# APPENDIX K

## Summary of Comments on Draft EA

**Table K-1: Summary of Comments from Public on Draft EA**

Ontario Geological Survey - Airborne Magnetic Survey - Eastern Ontario Area 2014 First vertical derivative of the magnetic field grid

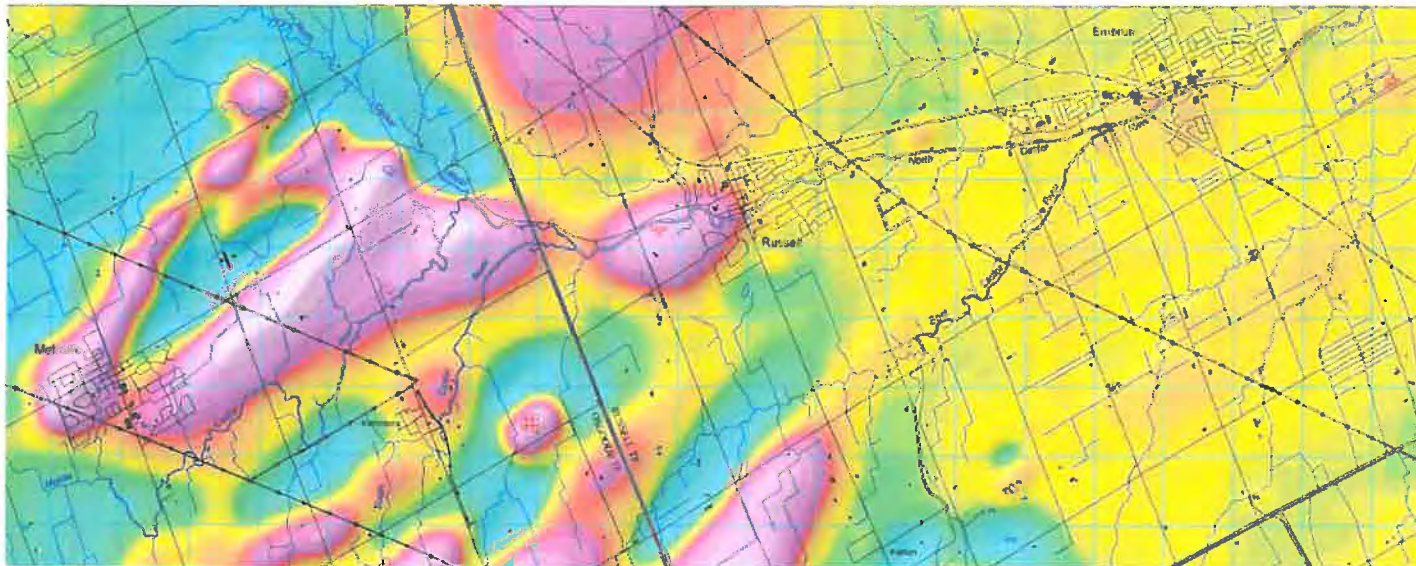
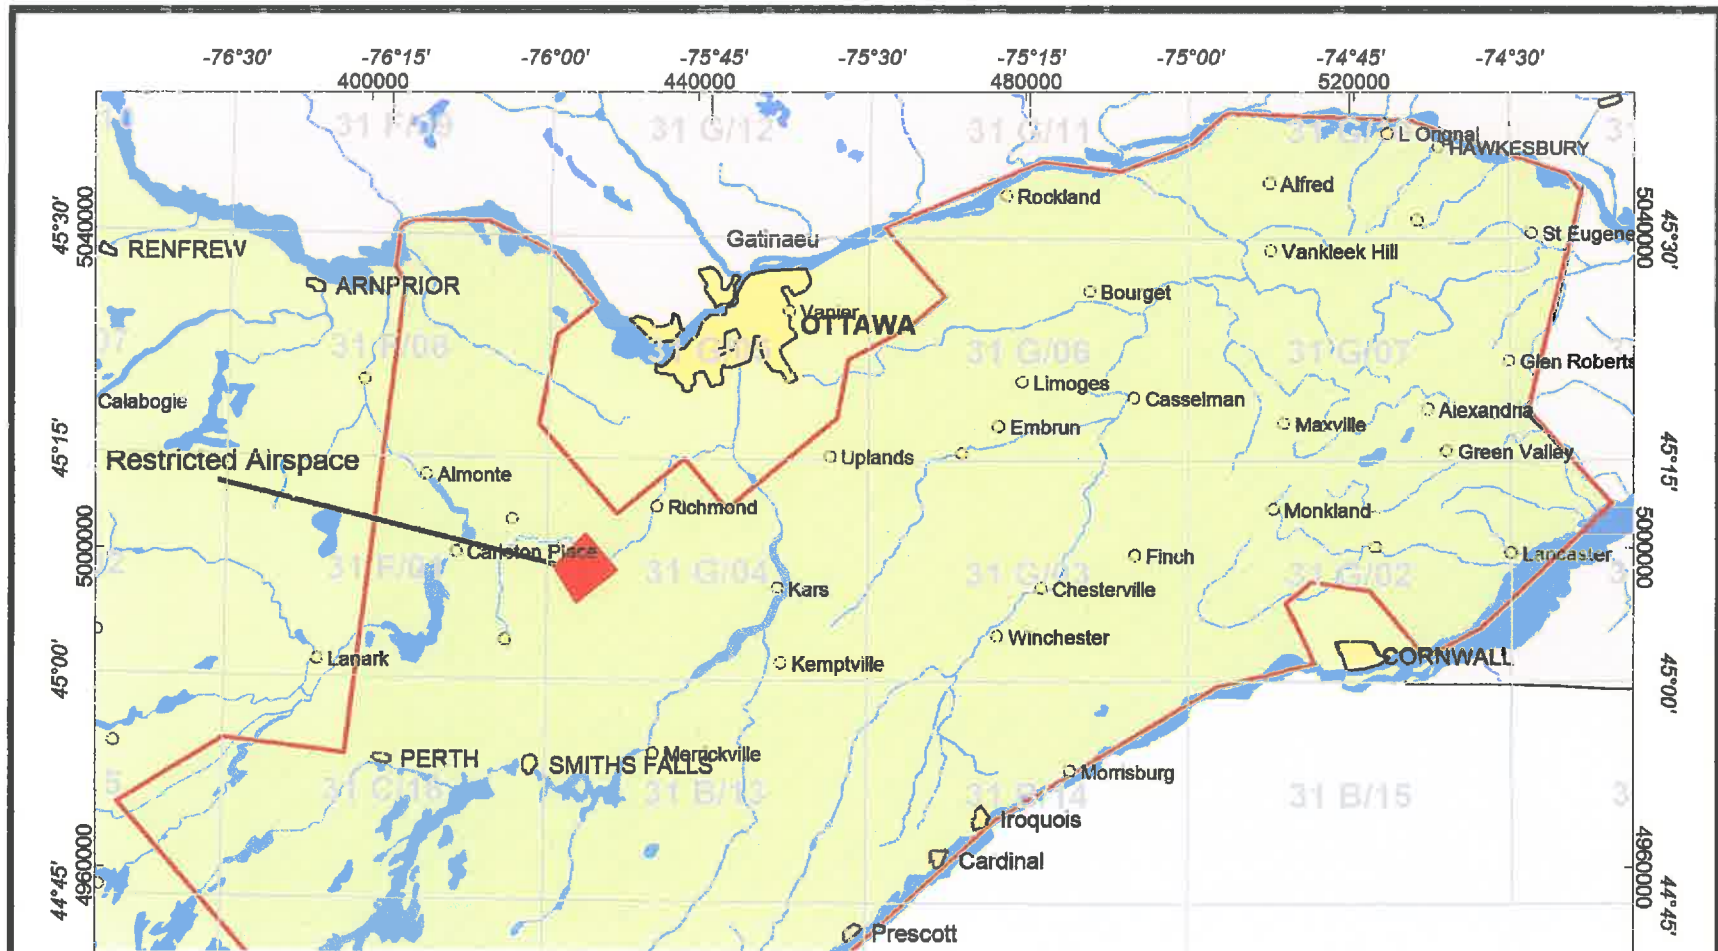
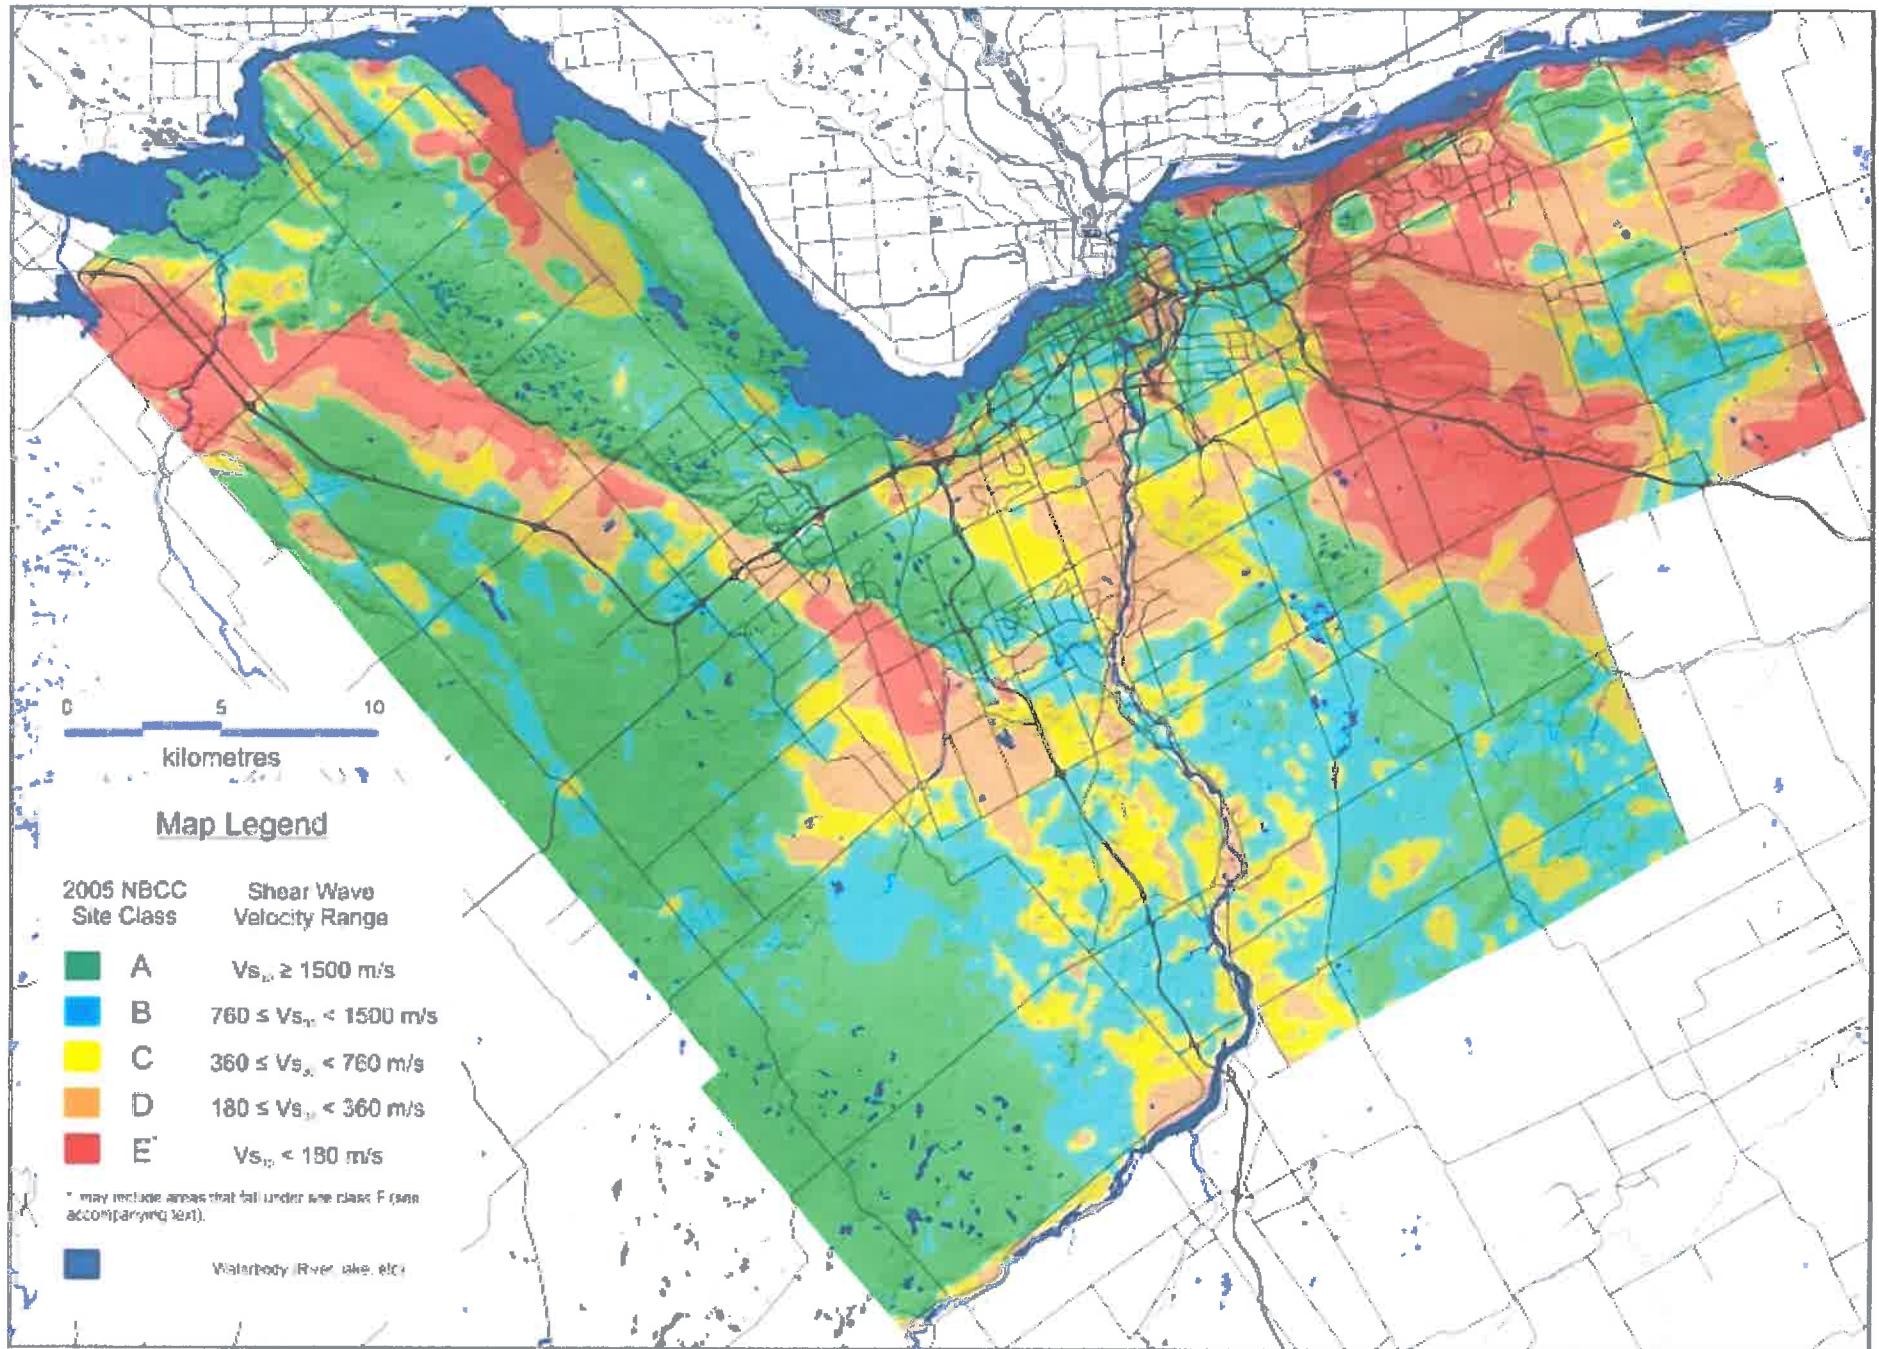
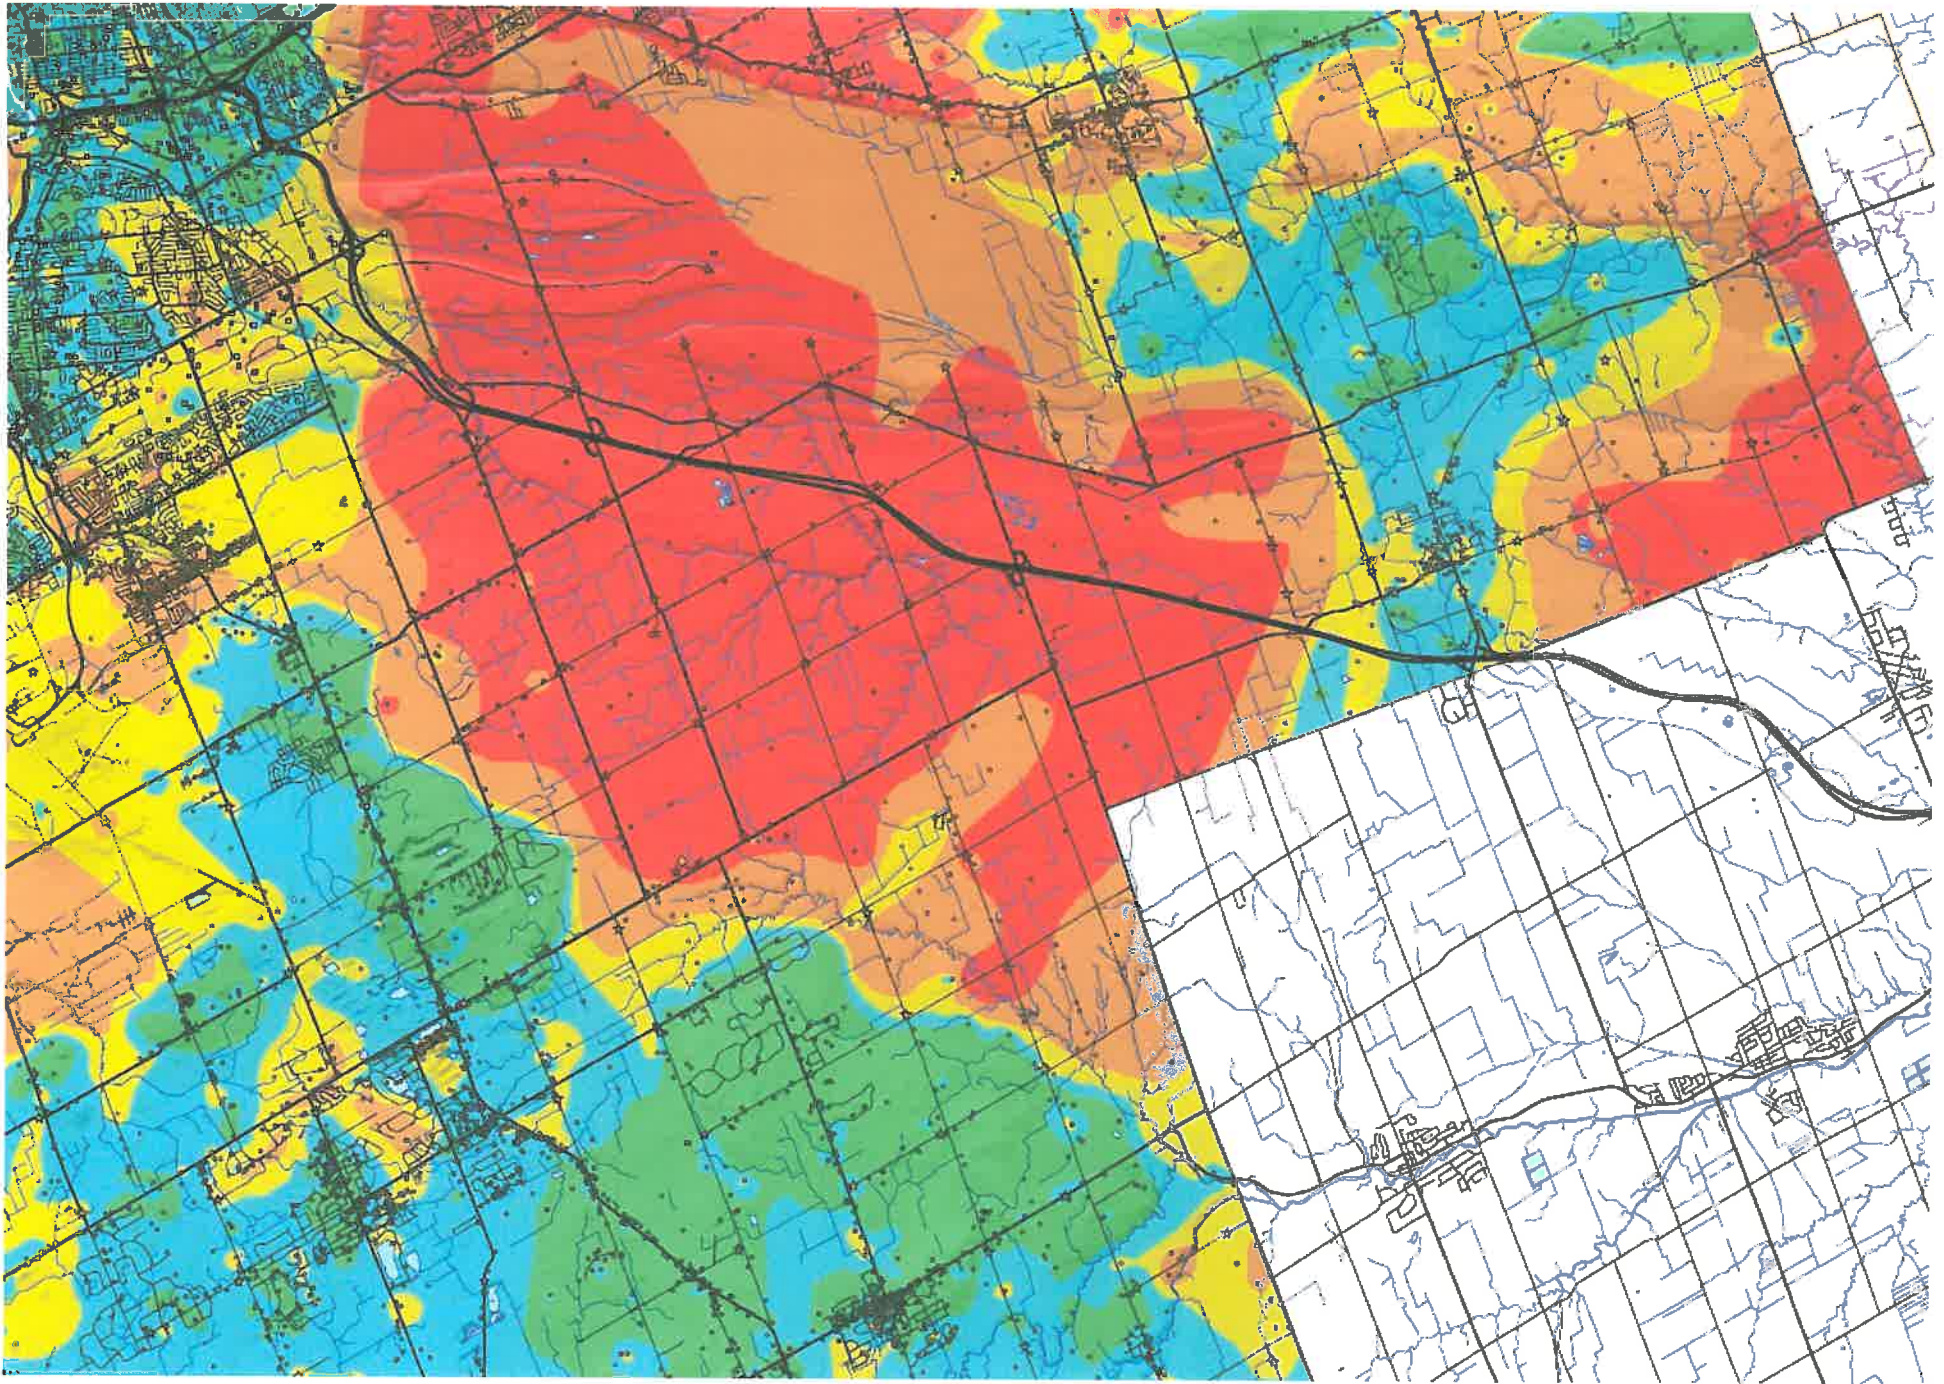
Appendix K-1-10	Individual 20	June 25, 2014	<p>Images and partial articles were provided by this individual at Open House #6 in relation to his review of the draft EA.</p> <p>1. The first attachment is the recent airborne geophysical magnetic survey map of the basement Precambrian geology in the area prepared by the OGS and published.</p> <p>2. The second map is the seismic site class map of the Ottawa area prepared by the GSC.</p> <p>3. The 3rd reference is about the big earthquake that this area could experience.</p> <p>4. The 4th reference is the paper from Brooks about the dating of large historic earthquakes that caused landsliding in the Quyon area, with the new information being that this occurred as recent as ~1,000 years ago. It builds on the work done east of the City by the GSC about the large historic quakes around 4500 and 7000 years ago.</p>	<p>No written response issued.</p> <p>1. The preliminary airborne total field magnetic survey was reviewed. The magnetic trends shown are consistent with the northeast-southwest structural trend of the Grenville age Precambrian basement that underlies the area. The Gloucester Fault is also indicated by offset magnetic patterns in the basement structure that approximately coincide with the known position of this structure.</p> <p>2. During the EA, site specific VSP testing was completed, the results of which show the Boundary Road Site to be Class E. This agrees with the GSC seismic site class map.</p> <p>3. Taggart Miller used M6 to M7 earthquakes in assessment of the CRRRC, so this reference does not add any new considerations for the assessment.</p> <p>4. The Brooks paper was reviewed. The location is over 100 km from the CRRRC Site and does not affect the relevant conclusions of this part of the assessment.</p>	<p>2. A reference to the seismic site class map of the Ottawa area was added to the EASR and it includes a statement that the map agrees with the results of Site specific testing.</p>
